SUBJECT: ADDENDUM #1

Date: October 27, 2026

Project: Site Work, Restroom & Fire Alarm Upgrades at Quail Valley Middle School
Snowline Joint Unified School District
FFJ Project No: SJ21-01
DSA File No.: 36-73 DSA Appl. No: 04-121057

EROSION CONTROL PLAN

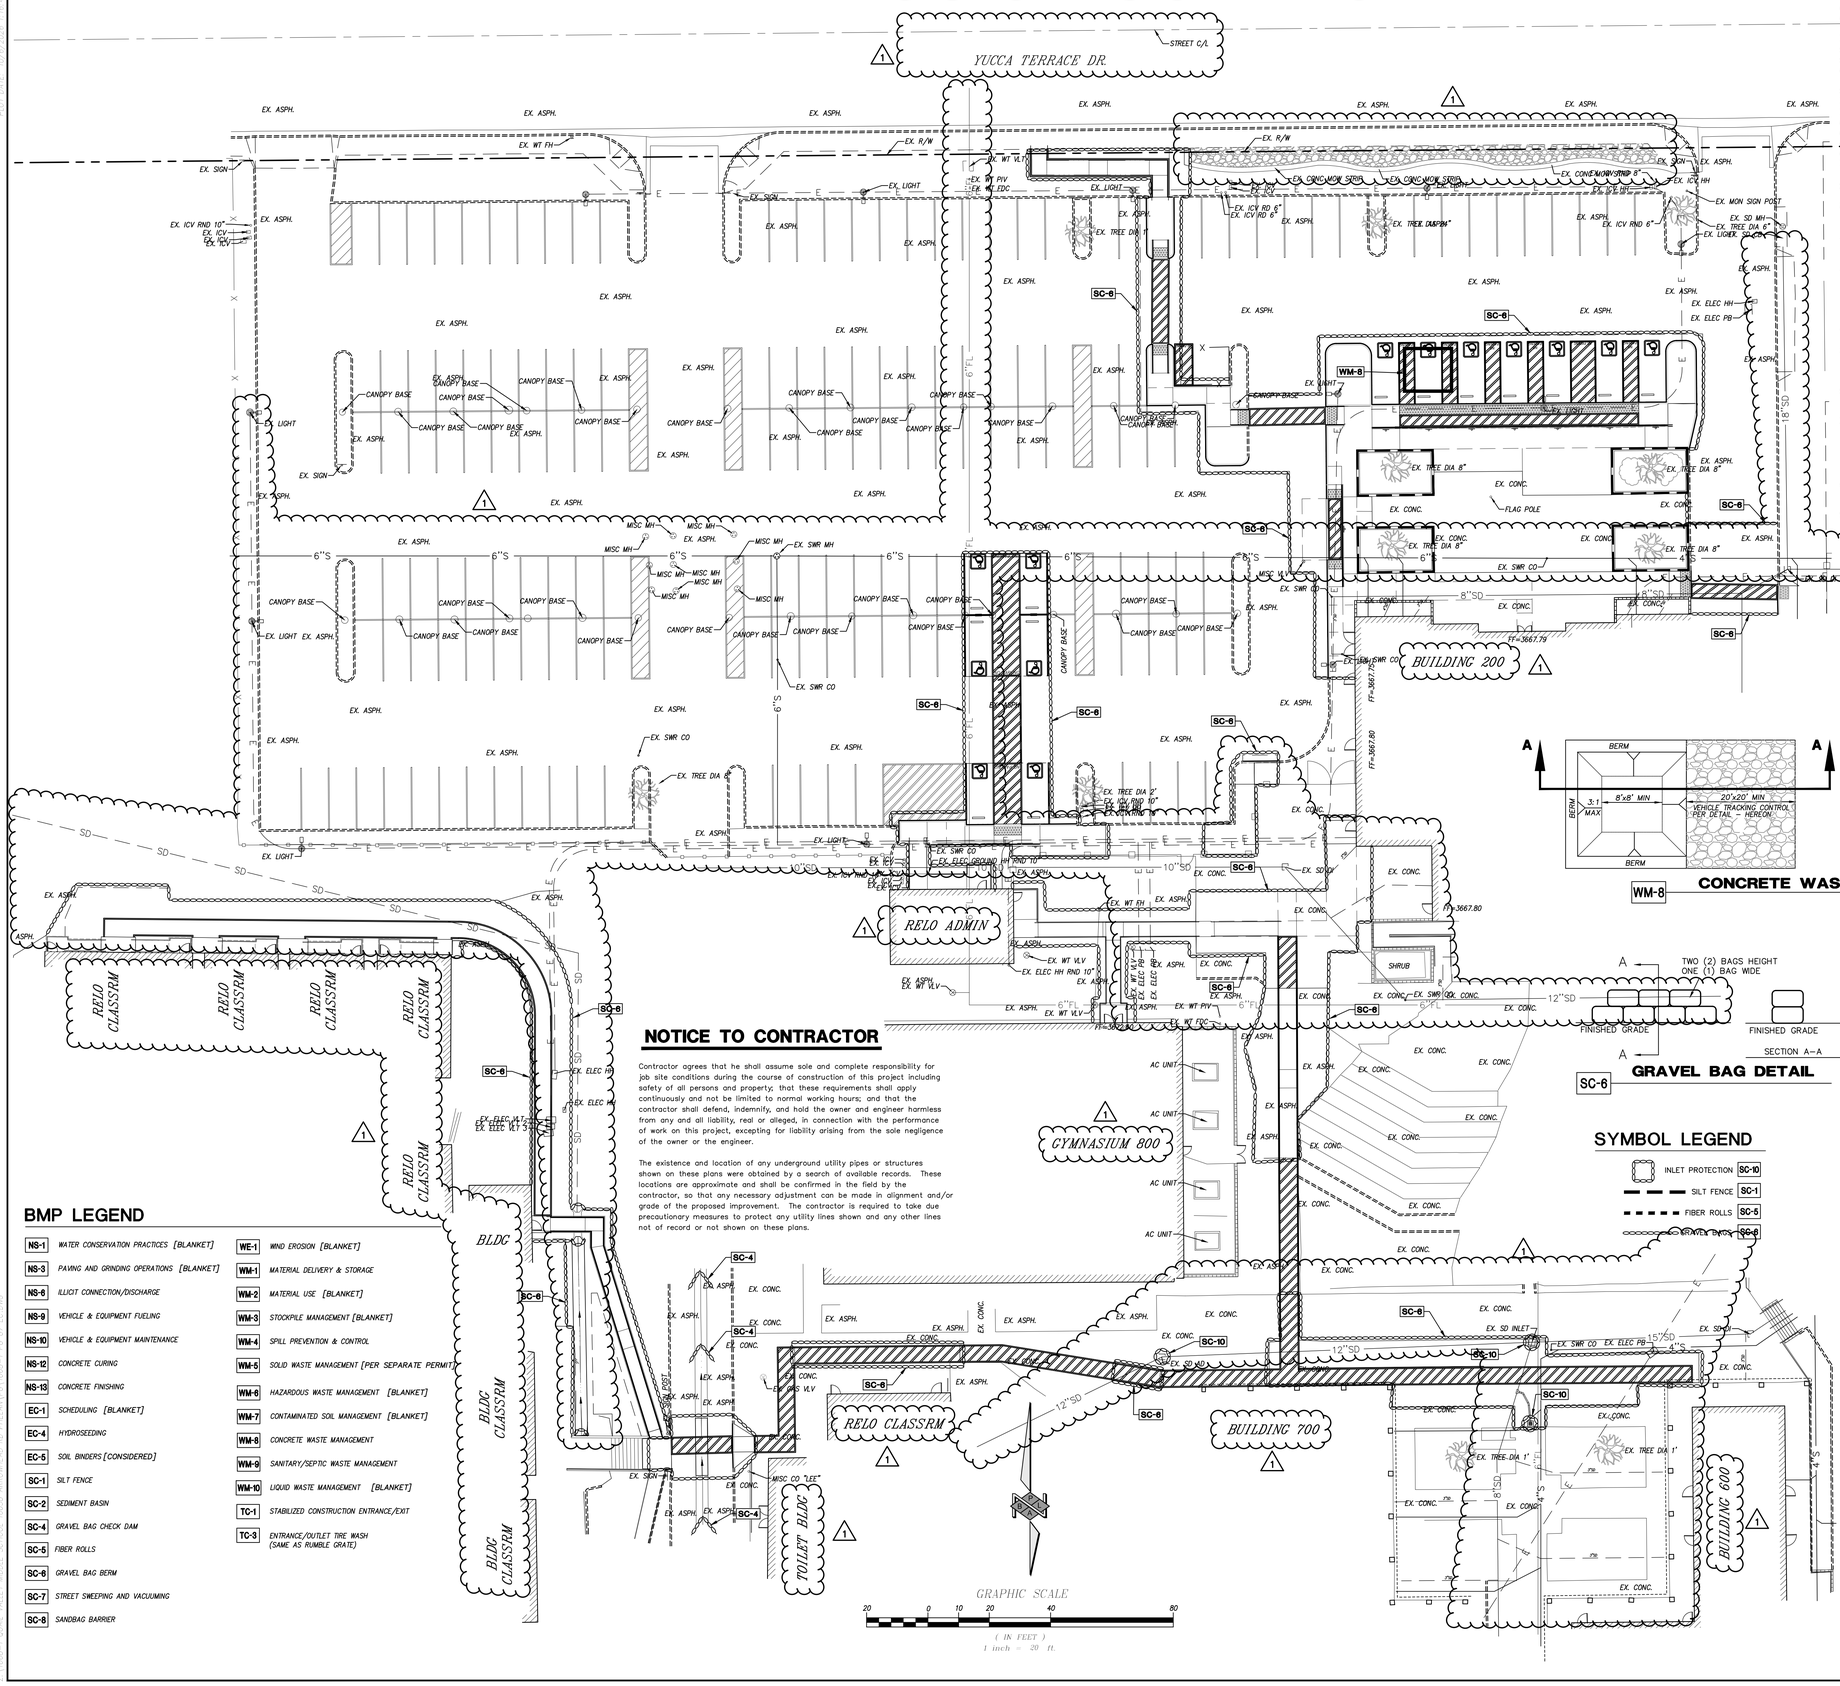
8. Sheet G-7 – EROSION CONTROL PLAN
- **a.** Building identification added.
- **b.** Concrete drainage ribbon added at ramp area northeast of relocatable classrooms.
- **c.** Street name added.
- **d.** Lines showing approximate location of utilities added.

ENLARGED DEMO SITE PLAN - PARKING LOT & MAIN CAMPUS

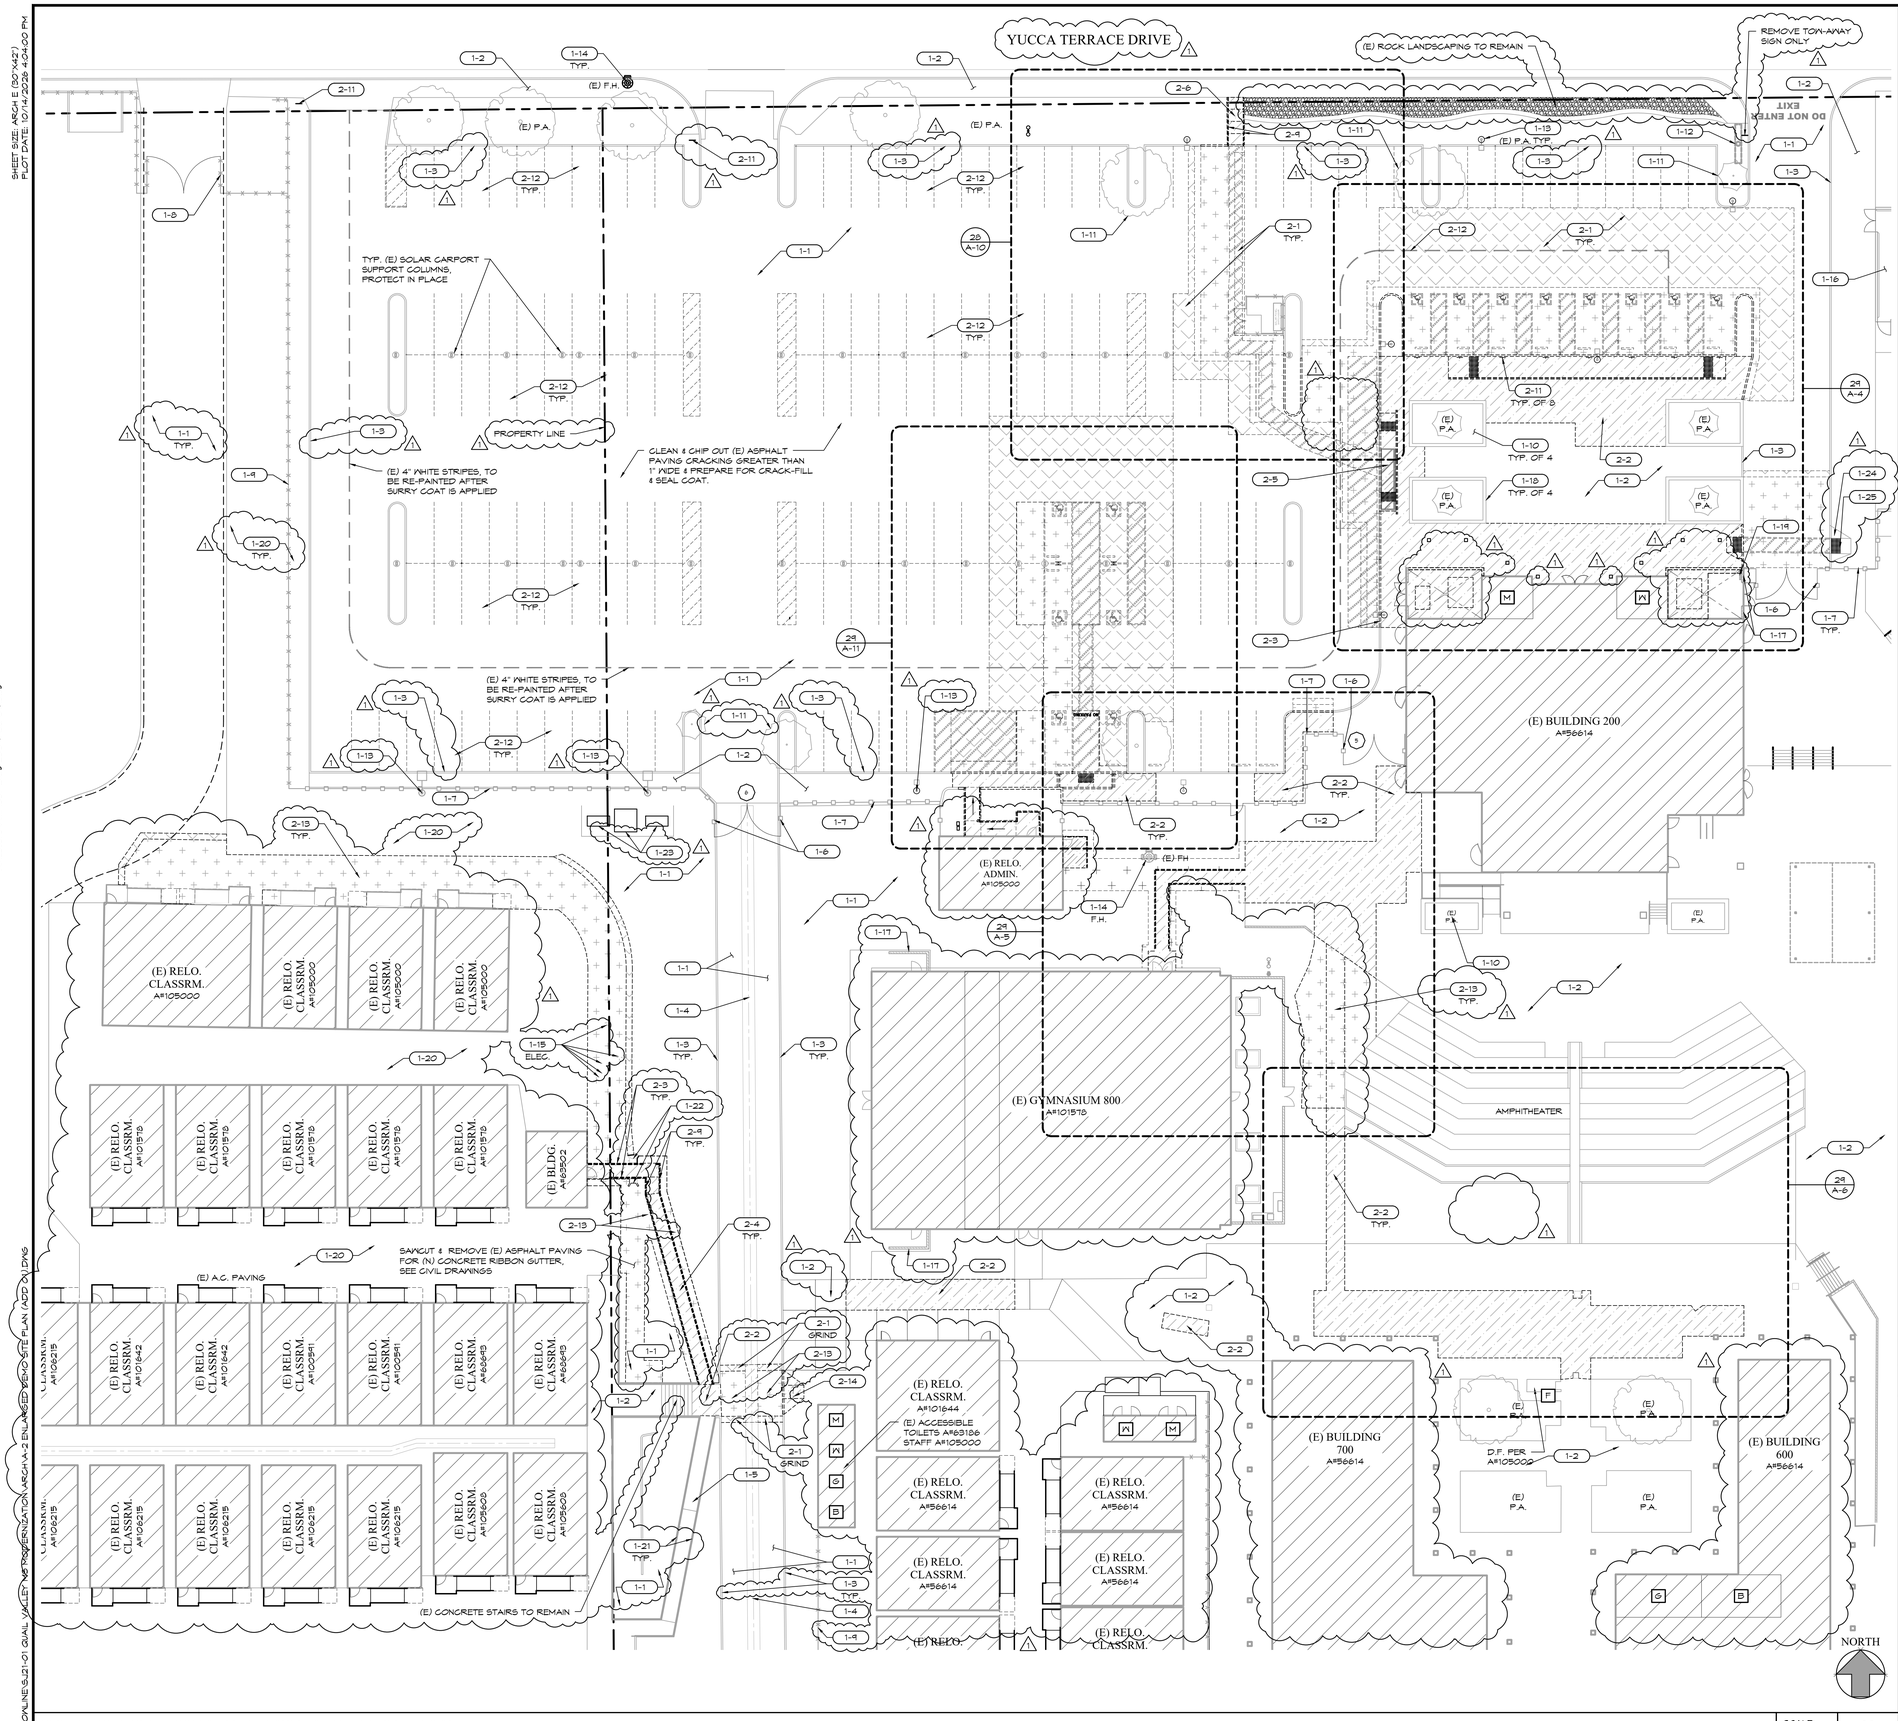
10. Sheet A-2 – ENLARGED DEMO SITE PLAN
- **a.** Updated keynote 1-14, 1-15, 1-17, 2-5 & 2-12 on Site Plan Keynotes.
- **b.** Added keynotes 1-20 to 1-28 & 2-13 to 2-19 on Site Plan Keynotes.
- **c.** Added street name to Detail 29.
- **d.** Updated and added keynotes at various locations to provide clarity to the scope of work being done to Detail 29.
- **e.** Added hatching to buildings where Fire Alarm work is being done to Detail 29.
- **f.** Added existing concrete paving to be removed Northwest of building 700 in Detail 29.
- **g.** Added existing rock landscaping to remain along Yucca Terrace Drive on Detail 29.
- **h.** Removed reference to Detail 16/A-12, because the detail was duplicate information and same scale as sheet A-2.

ENLARGED DEMO SITE PLAN - NORTH OF BUILDING 200

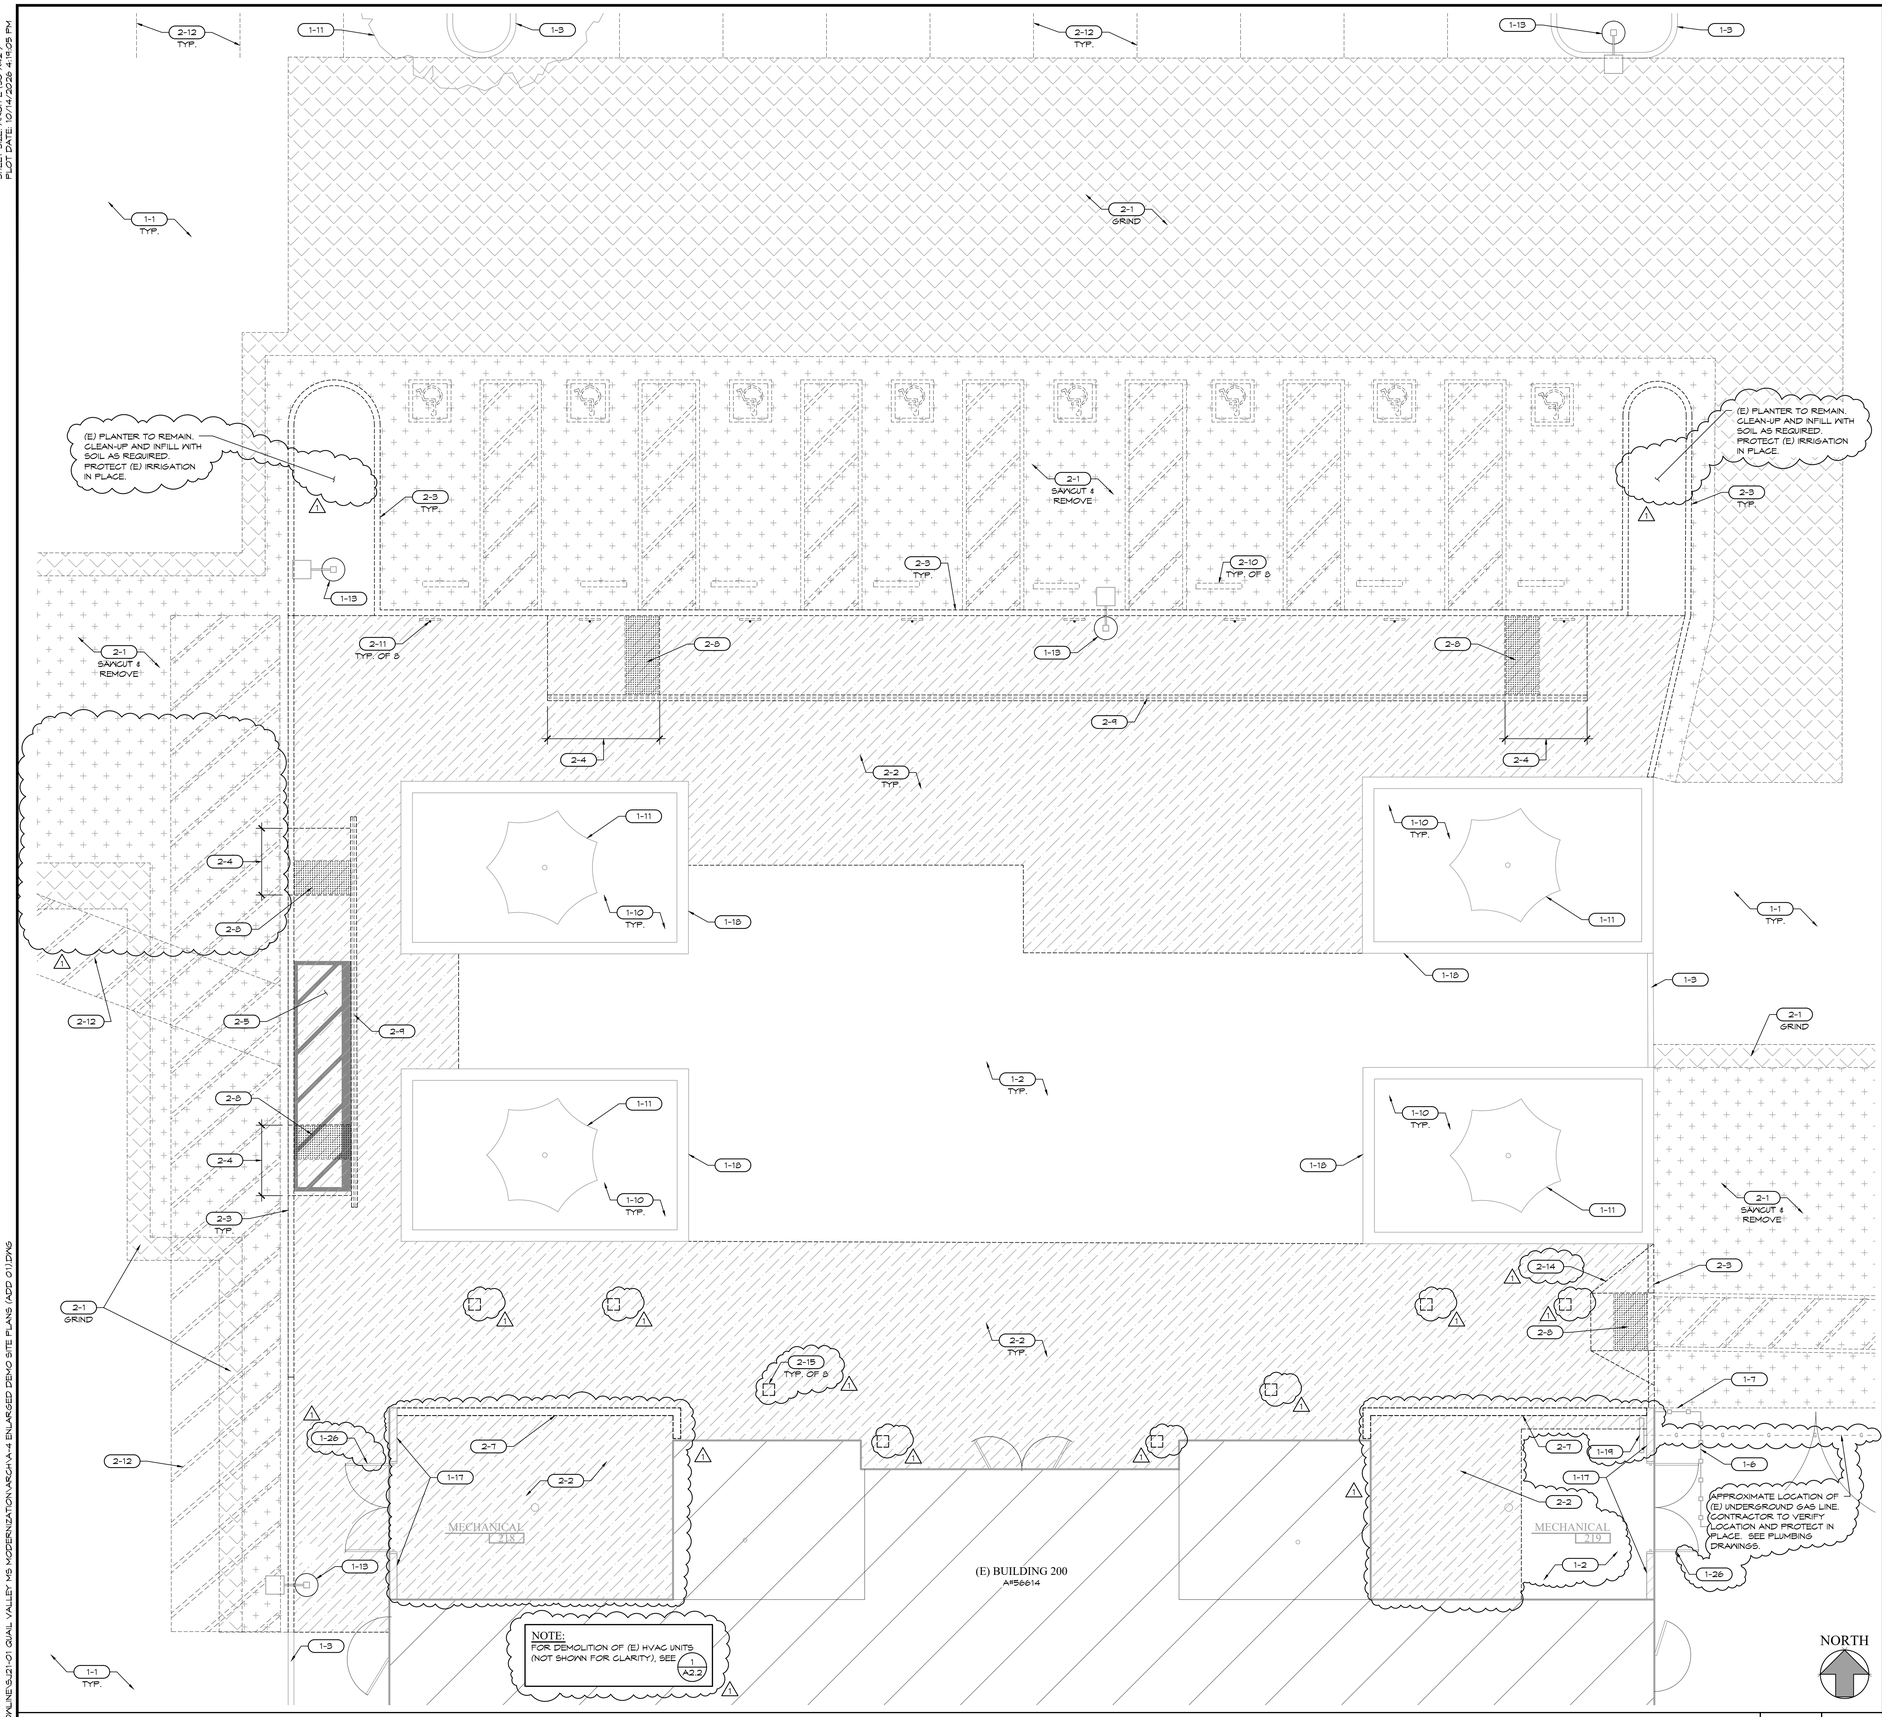
12. Sheet A-4 – ENLARGED DEMO SITE PLANS
- **a.** Updated keynote 1-14, 1-15, 1-17, 2-5 & 2-12 on Site Plan Keynotes.
- **b.** Added keynotes 1-20 to 1-28 & 2-13 to 2-19 on Site Plan Keynotes.
- **c.** Added notes to project, "Existing irrigation at existing planters that are being modified".

d. Updated and added keynotes at various locations to provide clarity to the scope of work being done to Detail 29.
e. Added existing ground mount architectural lights to be removed in concrete paving area North of Building 200.
f. Extended asphalt paving removal West of passenger drop-off being removed.
g. Extended concrete paving being removed at Mechanical Area/Room 218, North of Building 200.
h. Revised concrete paving being removed at Mechanical Area/Room 219, North of Building 200.
i. HVAC Demolition note added to Detail 29 (Lower Left corner).
j. Added hatching to buildings where Fire Alarm work is being done to Detail 29.
k. Added keynote 1-19 to identify the gas meter location in Mechanical Area 219.
